Submission of Further Information (FI)

**Proposed Temporary Warehouse (excluding Dangerous Goods Godown)
With Ancillary Office and Associated Filling of Land for a Period of 3 Years in
“Agriculture” Zone, Lots 1012 S.B, 1012 S.C, 1013, 1014 RP, 1015 S.A, 1015 S.B,
1015 RP, 1016 (Part), 1018, 1034 (Part) and 1035 in D.D.113,
Kam Tin, Yuen Long, New Territories
(Application No. A/YL-KTS/1125)**

Further Information for Planning Application No. A/YL-KTS/1125**Response-to-Comments****Comments from Environmental Protection Department**

1:1000	Layout Plan	Goldrich Planners & Surveyors Ltd.
May 2026	Lots 1012 S.B, 1012 S.C, 1013, 1014RP, 1015 S.A, 1015 S.B, 1015 RP, 1016(part), 1018, 1034(part) and 1035 in D.D. 113 Yuen Long, N.T.	Plan 3a (P 25012)

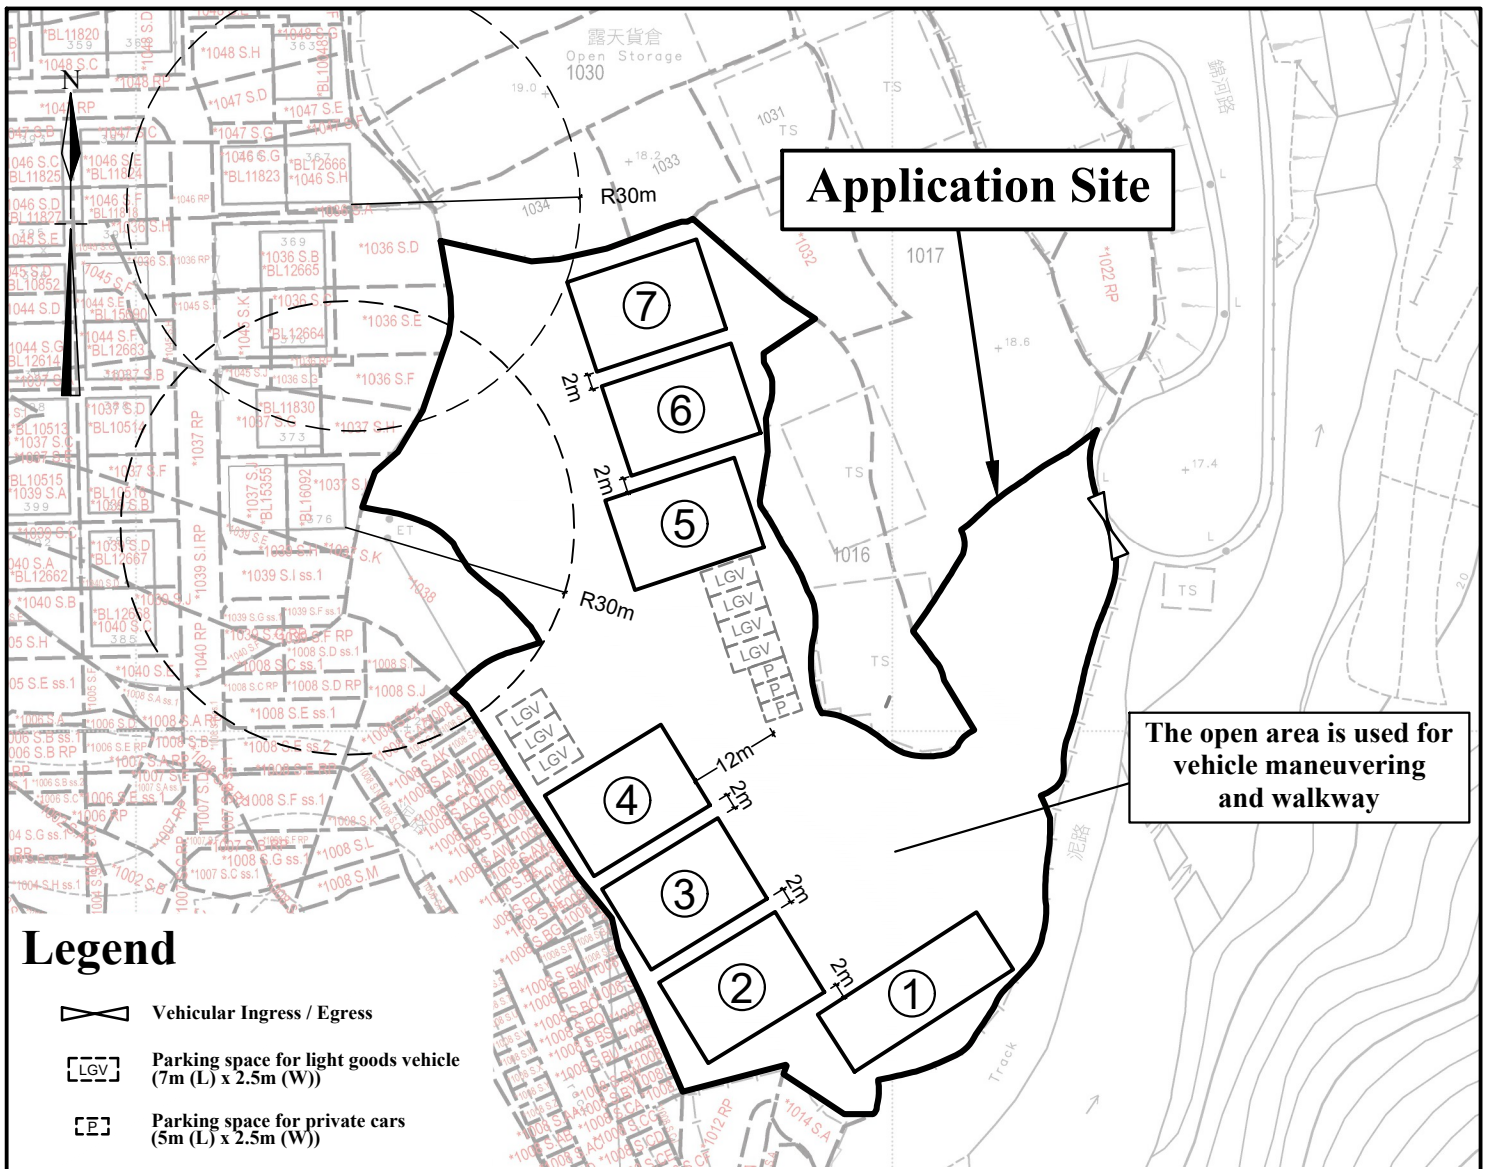
We would also like to clarify that light goods vehicles are proposed to be used for the daily operation of the proposed development. The average trip attraction and generation rates are relatively low (total trips of 7 attractions and 7 generations per day as mentioned in the Planning Statement). It would not disrupt/affect the daily life of the local residents. The operation hours are restricted from 9 a.m. to 7 p.m. daily from Mondays to Saturdays. Beyond operation hours, no vehicle travel to/from the site will be allowed. Drivers will be reminded to pay more attention to the pedestrians on the road. As such, the proposed development should not cause adverse traffic impacts to the adjacent areas and road network.

In view of the amendment made, we enclose the revised pages of the application form, planning statement (Appendix I), Layout Plan (Plan 3a) and Swept Path Analysis (Plan 4a) for your consideration.
